Appendix A: Road Safety Audit

Figure 25 - Horse Warning Sign East of Todd Lake Intersection, Looking West

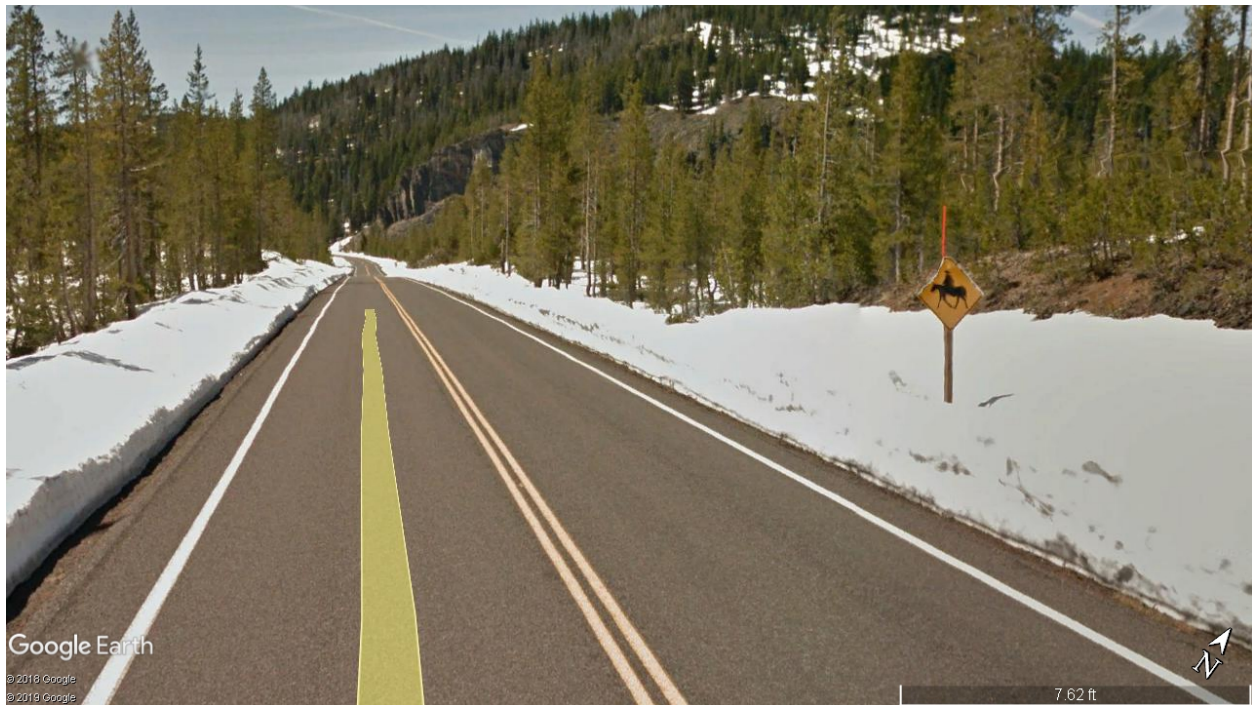
To the east of the intersection, a warning sign for equestrian use is shown in Google Earth for the eastbound direction.

East of this sign, there is another equestrian warning sign for the westbound direction. This indicates a regular crossing may occur in between the two signs. There are no known issues with crossings in this area. CLH is on a tangent through here with apparent adequate stopping sight distance.

Figure 59 - Intersection with S. Century Dr., North Approach (Approx. 140' north of intersection), Looking South

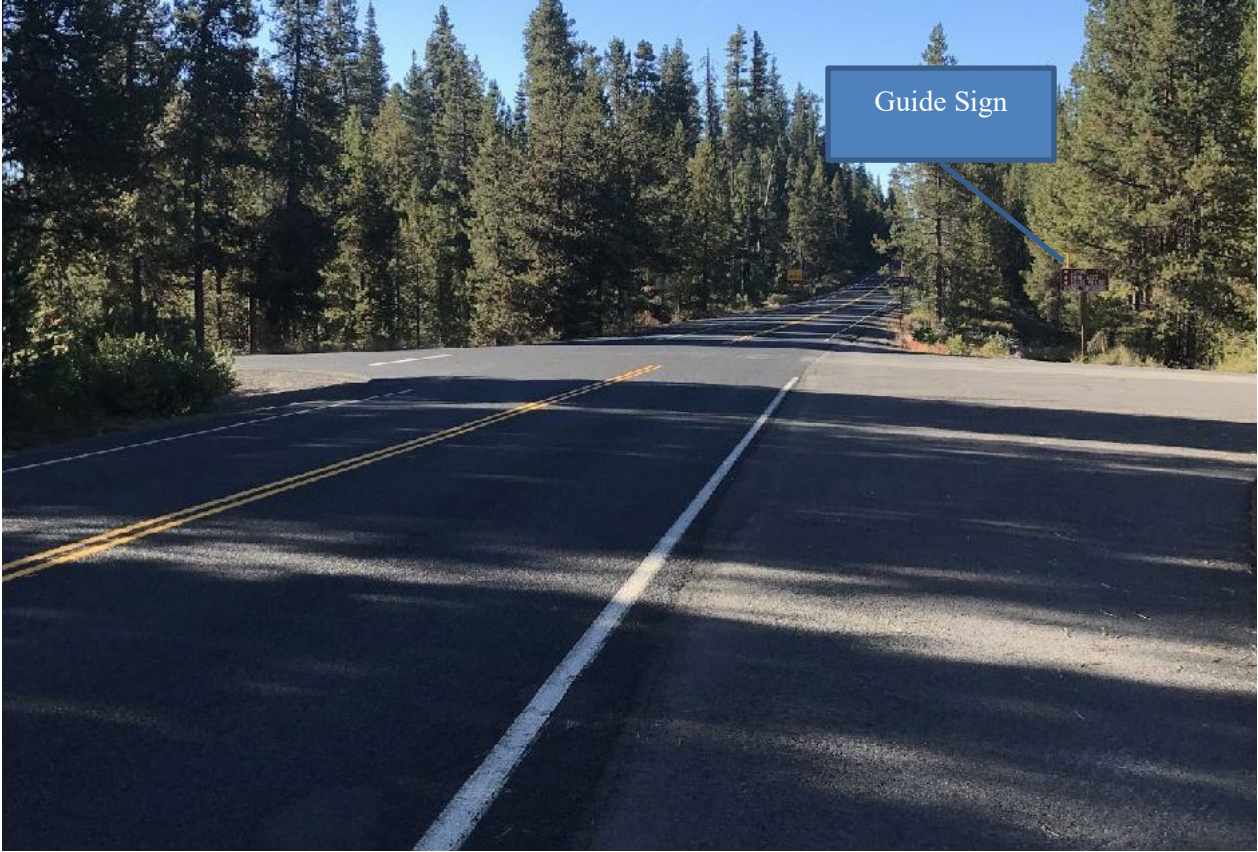
Approaching the intersection from the north, the first guide sign is located right at the intersection so it is easy to miss or requires a motorist to slow down from 55+mph in order to read the details.

There is an existing widened area to pullout here if a motorist is unfamiliar with the geography but this sign could be missed or lead to safety concerns with motorists slowing down in the roadway to read signs.

Figure 68 - Todd Lake ISD Improvements

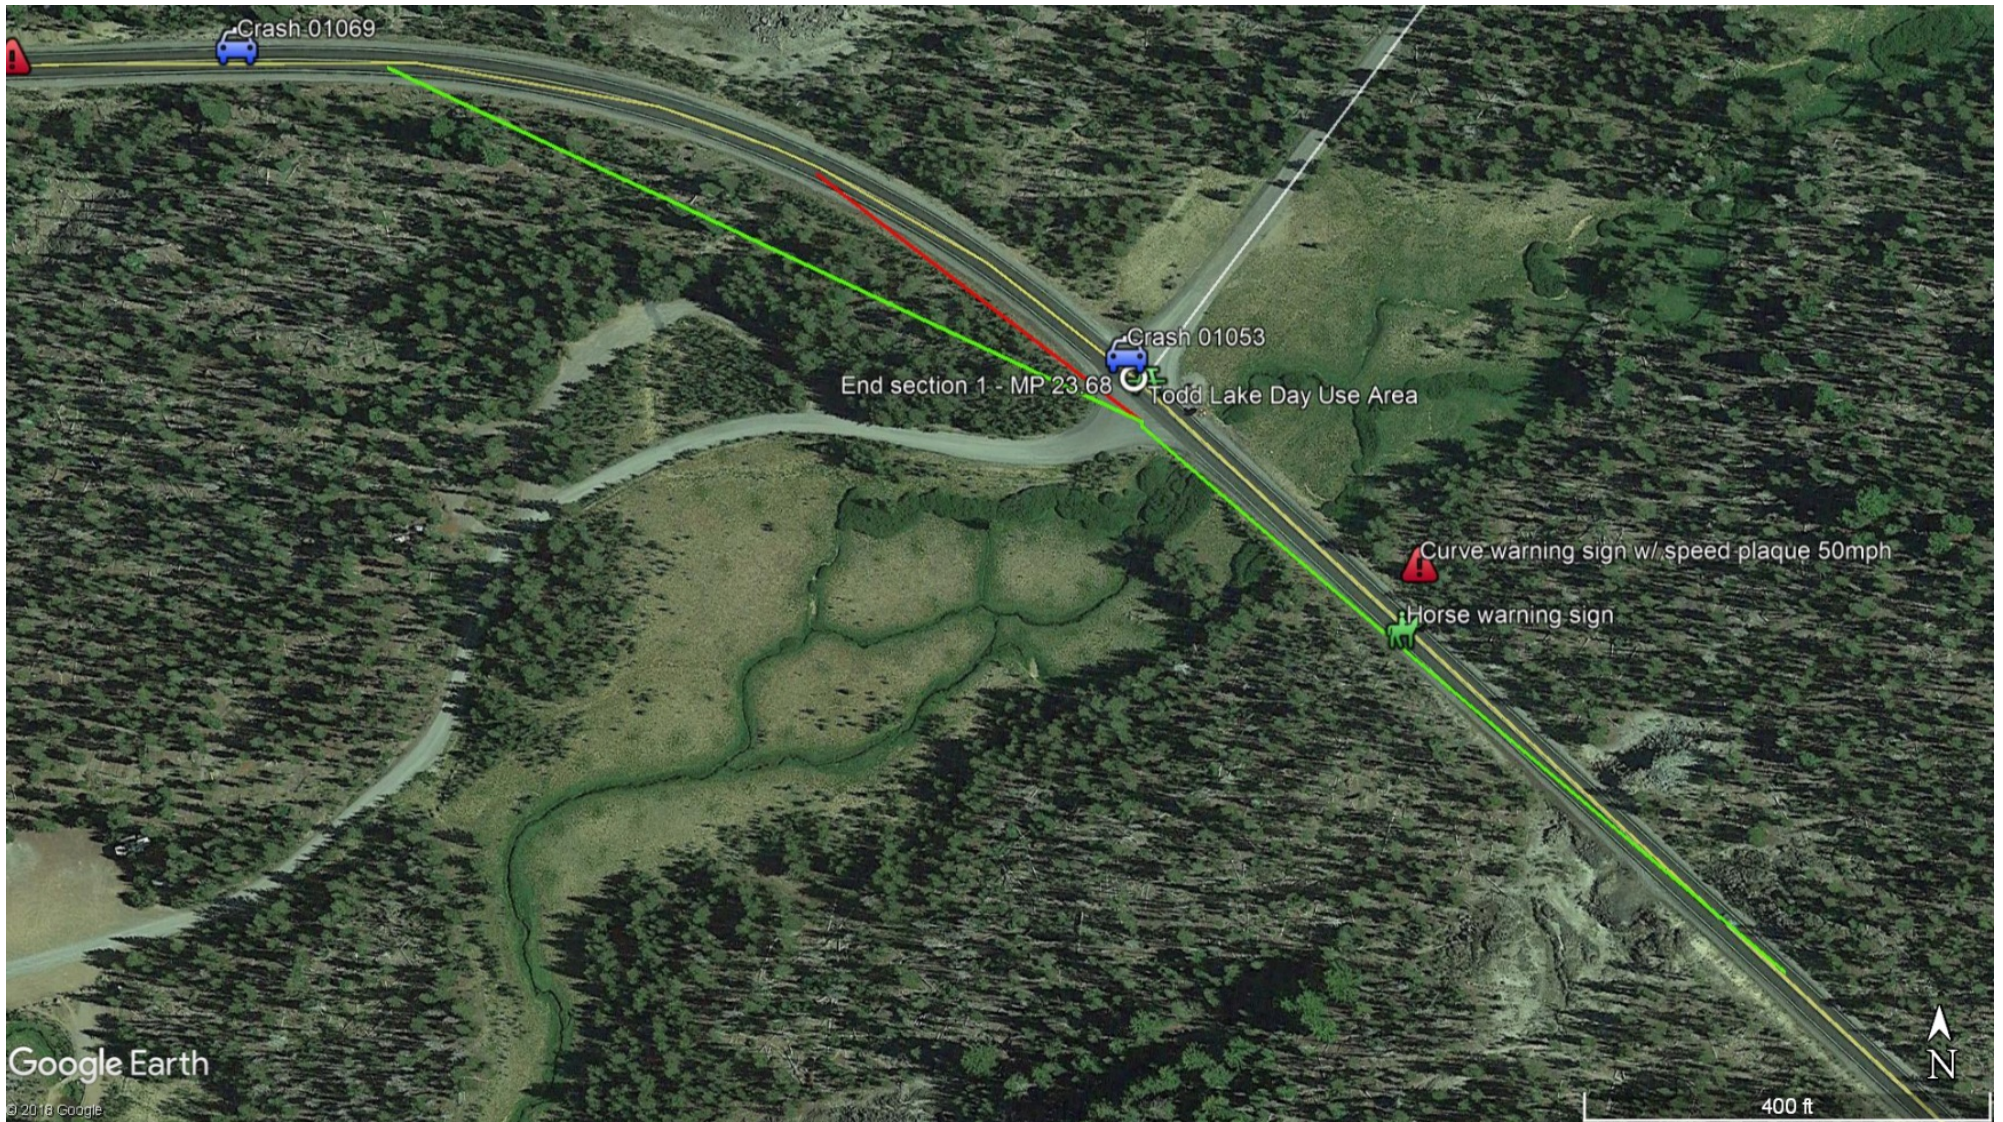
The Todd Lake intersection is near the end of a horizontal curve to the west. Figure 23 and Figure 24 show the reduced intersection sight distance due to vegetation and trees growing along the roadside. Removing these trees and vegetation to establish clear sight triangles is recommended. There is no official speed data at this time for CLH, but based on anecdotal evidence from LEOs, using a design speed of 60mph is recommended rather than the 55mph basic rule speed. Chapter 9.5 in the Green Book gives criteria for intersection sight distance for various scenarios. For the Todd Lake intersection, Case B1 is the controlling case for vehicles making turns out of either approach road. Table 9-5 gives time gap values used to calculate the recommended intersection sight distance (ISD). The traffic mix along CLH is generally passenger cars (and pickup trucks) but there are significant amounts of vehicles pulling trailers especially at some locations like the equestrian area on the south approach of the Todd Lake intersection. Vehicles pulling trailers require more time to pull out of the approach and into their respective lane along mainline. Due to a high use of vehicles pulling trailers at this intersection, the “Single-unit truck” time gap value of 9.5 seconds is used to approximate this effect. The calculation from equation 9-1 gives an ISD of 838’, rounded to 840’ for design. Figure 66 shows the existing ISD to the west in red and the theoretical ISD in green (840’).

It can be seen that substantial clearing would be needed to the west of the intersection. Some of this clearing would need to occur outside of the assumed 50' easement from centerline of CLH. If this is not possible, it is recommended to clear as much as possible to improve ISD to the maximum extent practical. Adding warning signs as noted below is recommended in either case.

While traffic studies along CLH and at the intersections would help identify major intersections relative to the corridor, it is believed anecdotally that Todd Lake is a high-use intersection. It is recommended that W2-1 signs be added in advance of the intersection from both directions.

Figure 72 - Deschutes National Forest South Sister Climber Trail Reroute Proposal¹⁸

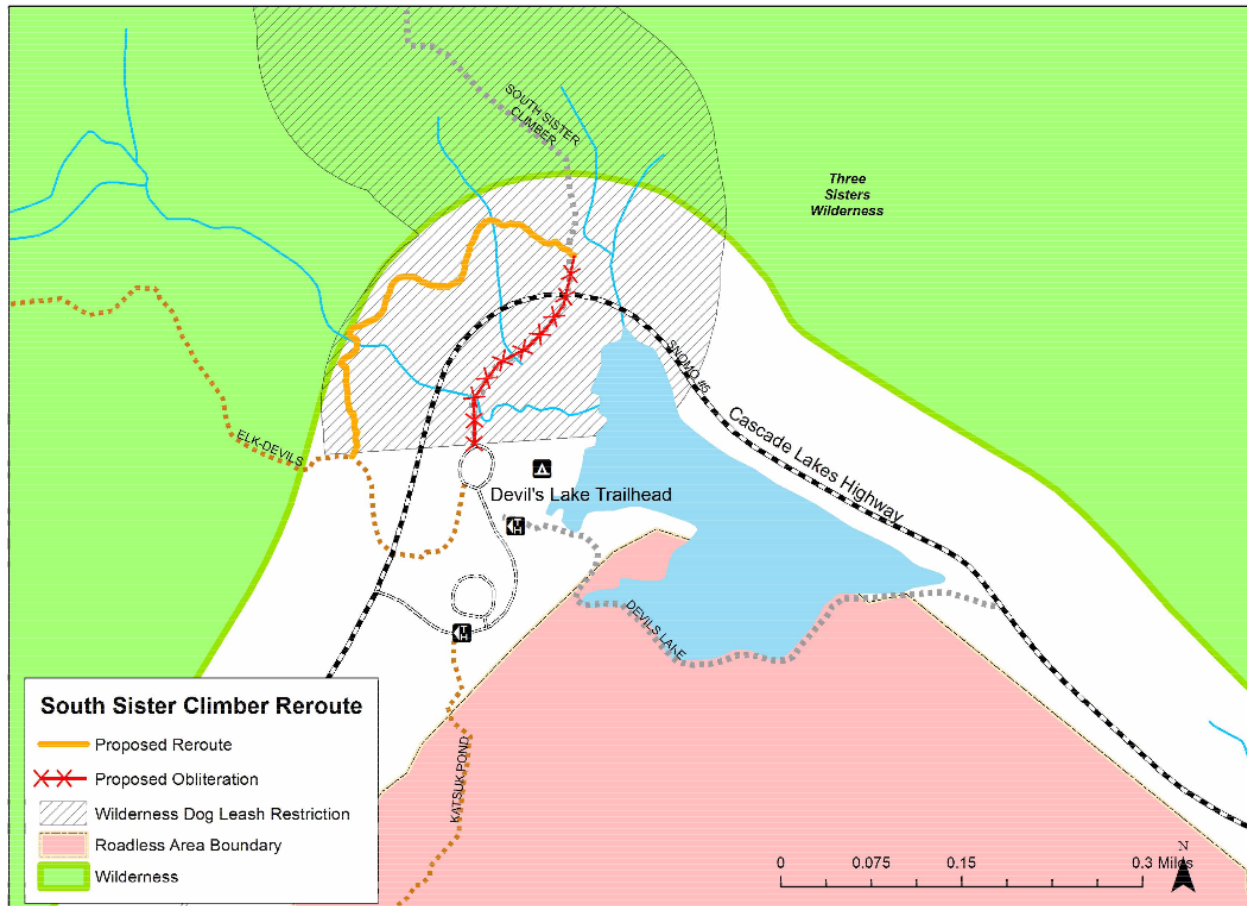
A secondary proposal by the Forest Service at this location is the trail reroute of the South Sisters Climber Trail #36 to start and coincide with the Elk Devils Trail #12 before branching off to be rejoined with the rest of the South Sisters Trail. This means that the South Sisters Trail would no longer officially cross the CLH and would instead share the underpass on the Elk Devils Trail #12. Assuming this proposal proceeds to completion, this will also significantly improve the safety of hikers and pedestrians in this area. Trail users can then park in the Devils Lake parking lot and cross under CLH to access either trail.

While the proposed Wilderness Area strategies will likely nearly eliminate parking along CLH to access the trails as well as pedestrians crossing across the highway, there is still a chance that trail users will inadvertently or deliberately park along CLH to access the trails based on previous experience or a desire to park as close to the trails as possible. There is still a chance that there will be pedestrian crossings as well with the large turnout located on the inside of the curve, etc. The team offers strategies to reduce this likelihood.
